ADDENDUM NO. 1

ROWE
Federal Aid Project No. STP(BR-OFF)-003S(739)X
Superstructure Replacement, R-10-008, Cyrus Stage Road over Potter Brook

ROWE
Federal Aid Project No. STP(BR-OFF)-003S(739)X
Superstructure Replacement, R-10-008, Cyrus Stage Road over Potter Brook
(Proposal No. 608855-126249)

Questions and Responses

TYPICAL ABUTMENT SECTION 1
SCALE: 1/2" = 1'-0"

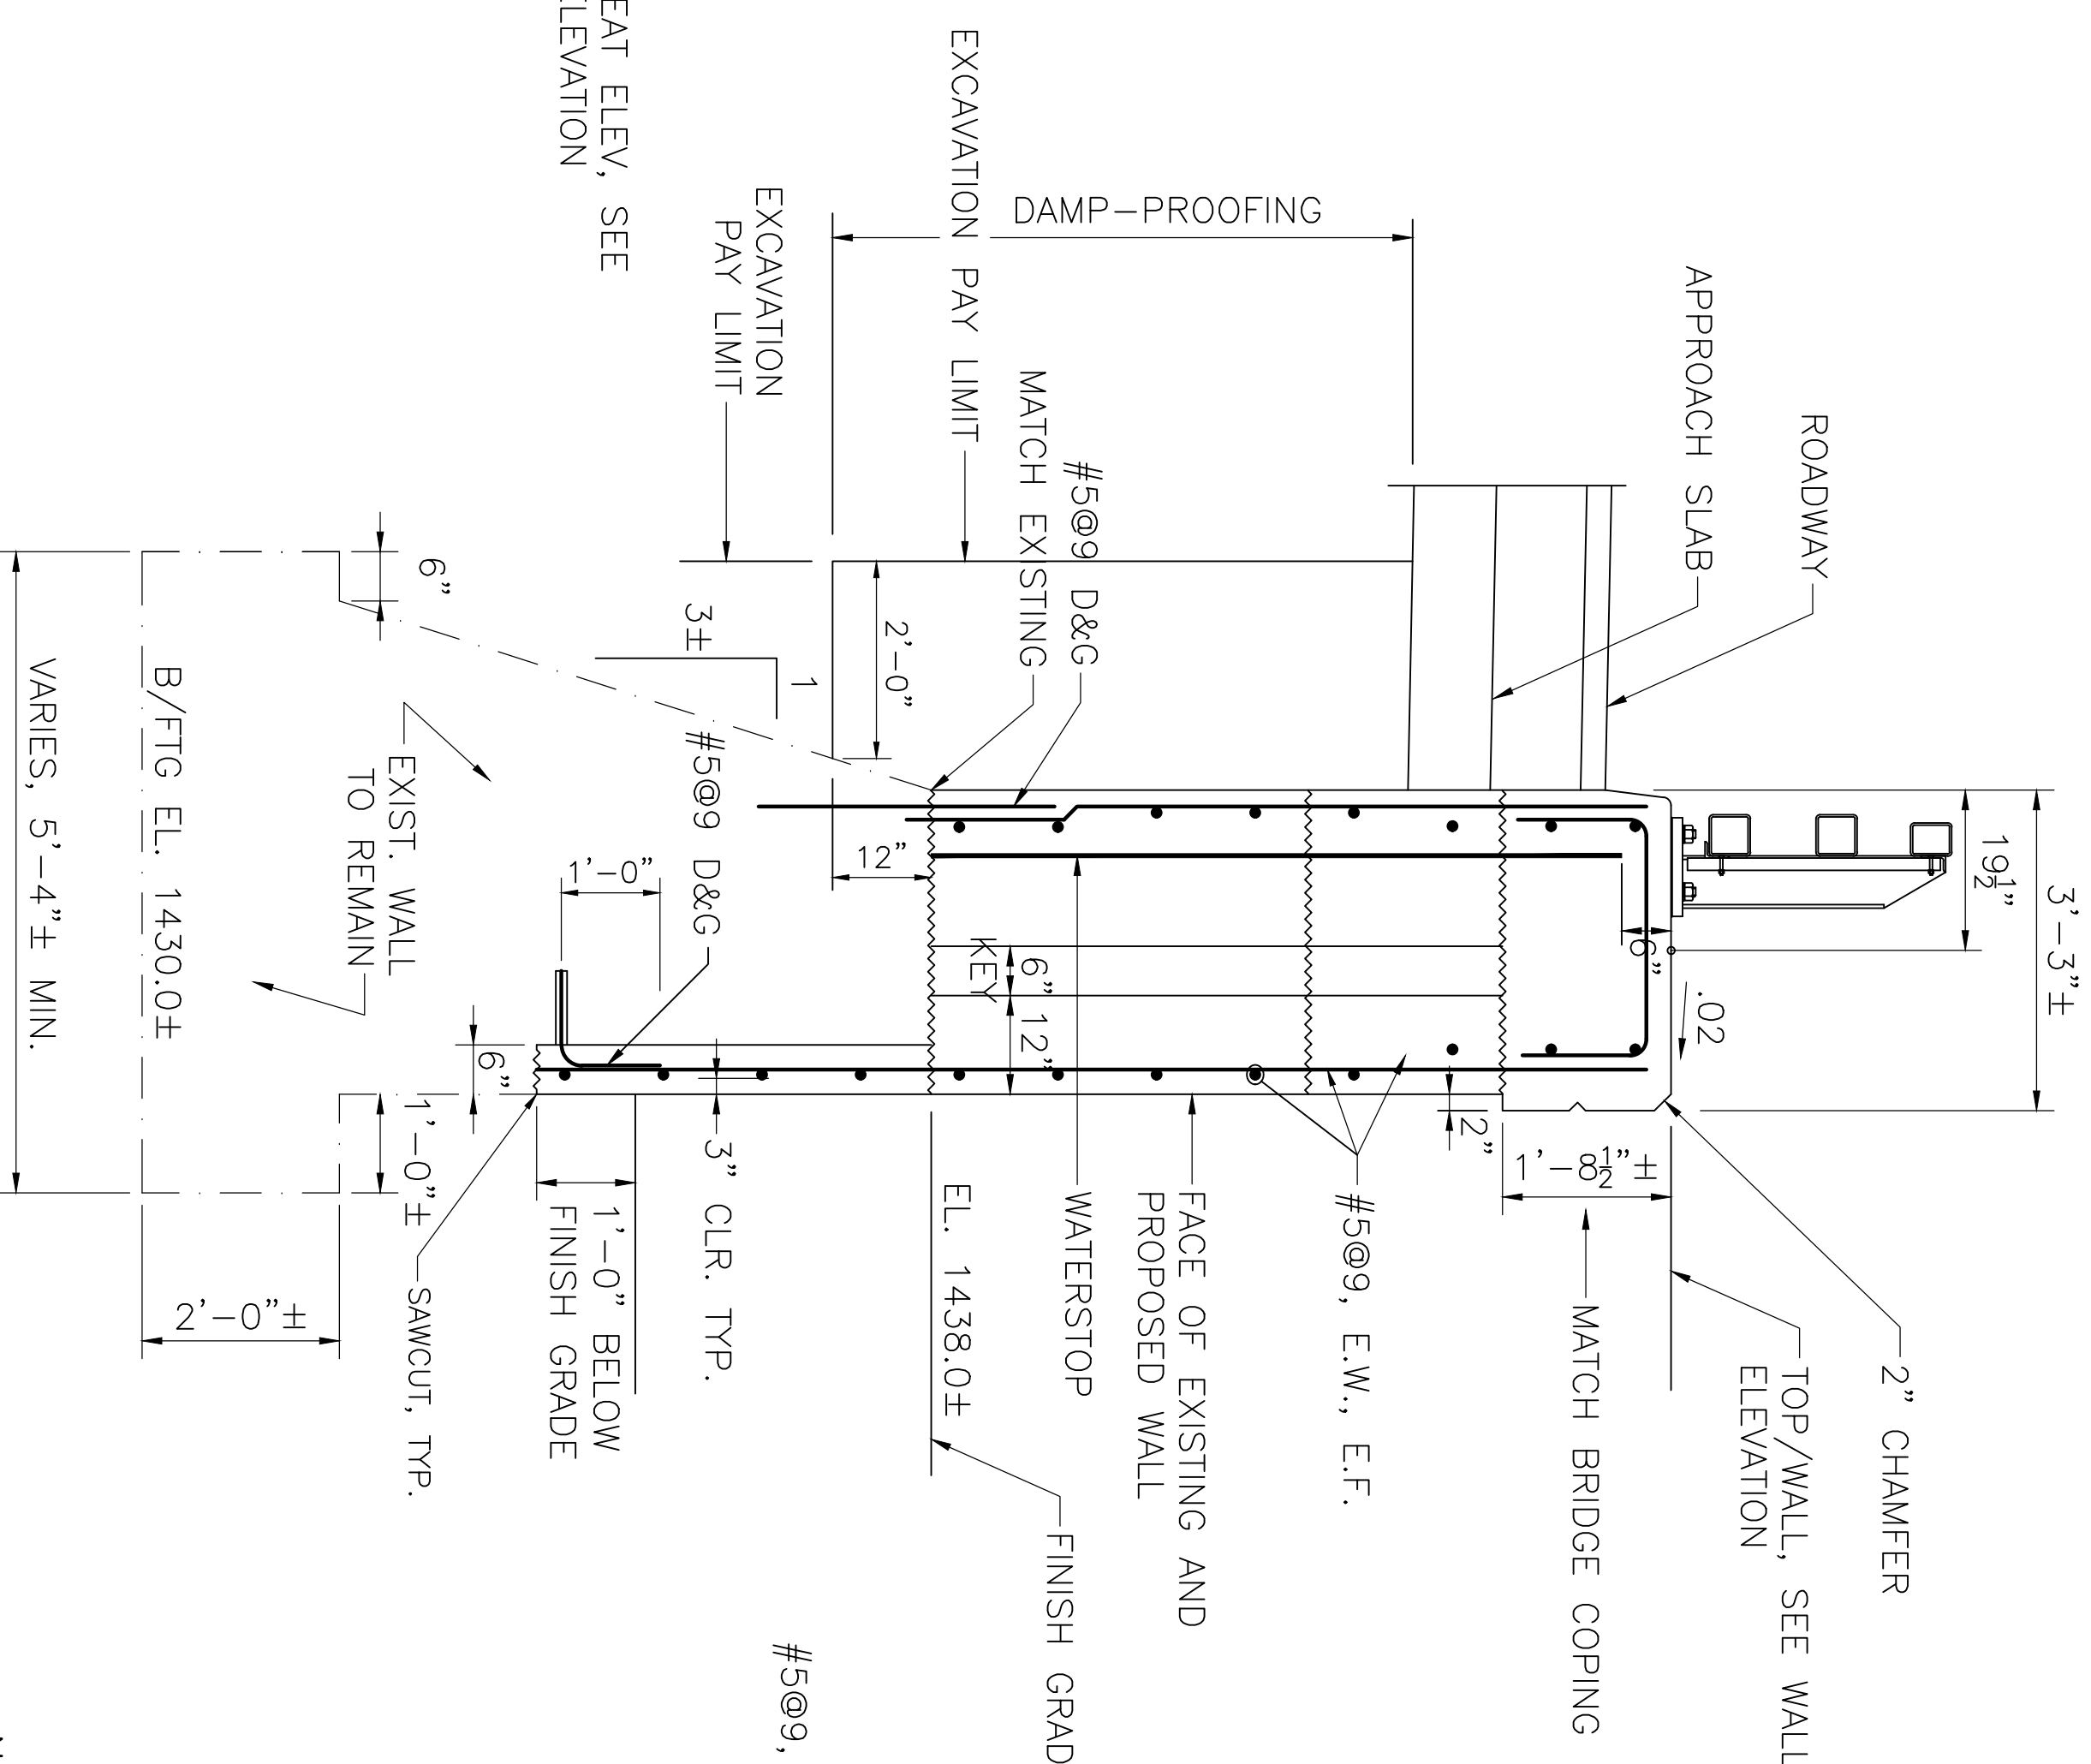
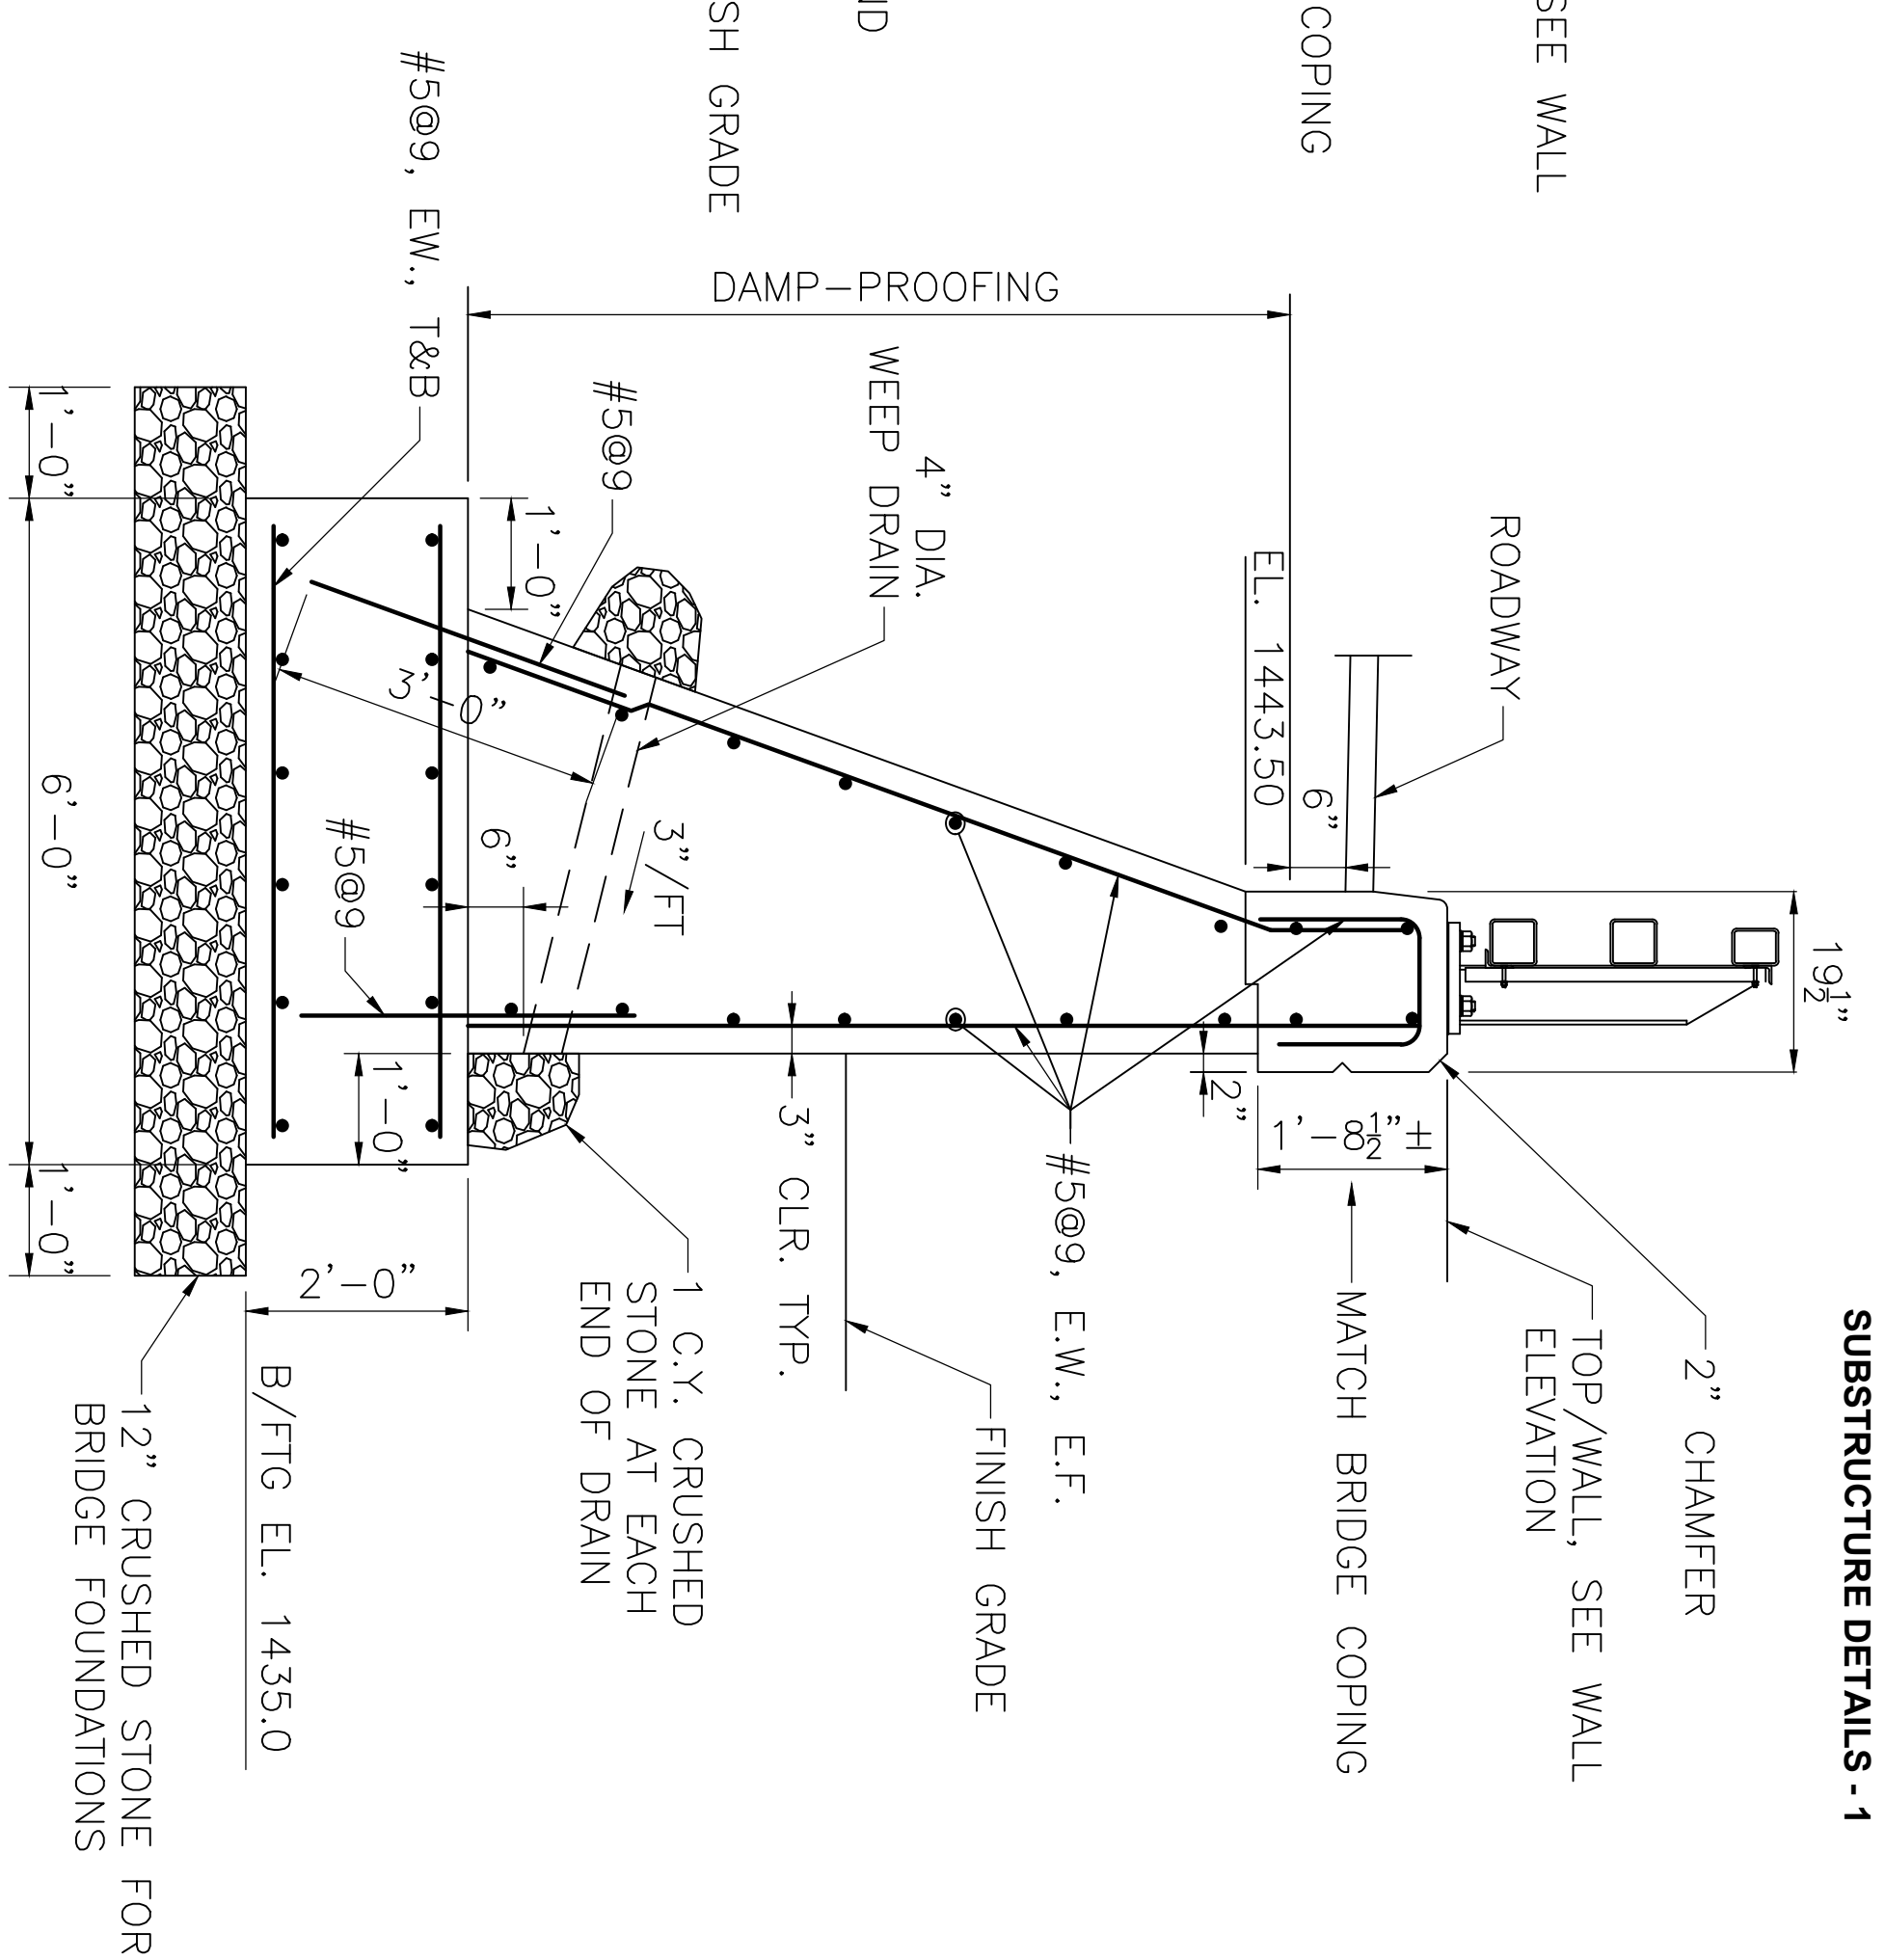
Question 3) Please refer to sheet 13 of 25 of the bridge drawings. It appears that the proposed precast highway guardrail transitions are going to conflict with the existing abutment sections that are to remain. Please provide additional details regarding these proposed guardrail transitions and how they will tie-in to the existing abutment.

- Question 4) Please refer to sheet 23 of 25 of the bridge drawings, detail: “Precast Guardrail Transition Plan at NW, SW, and NE Corners.” It doesn’t appear that this detail matches the curtain wall layouts shown on the abutment drawings, particularly on the SW and NE Corners. At the SW and NE Corners, it appears the curtain walls extend beyond the limits of the existing abutment at the demolition limit. Please clarify and provide further details on these curtain walls.
- Response 4) See revised Plan Set Sheets Nos. 29, 30, and 31 of 50.

Response 3) See revised Plan Set Sheets Nos. 29, 30, and 31 of 50.

DATE	DESCRIPTION
7/10/2024	SECTION 25 ADDED
6/8/2024	ISSUED FOR CONSTRUCTION
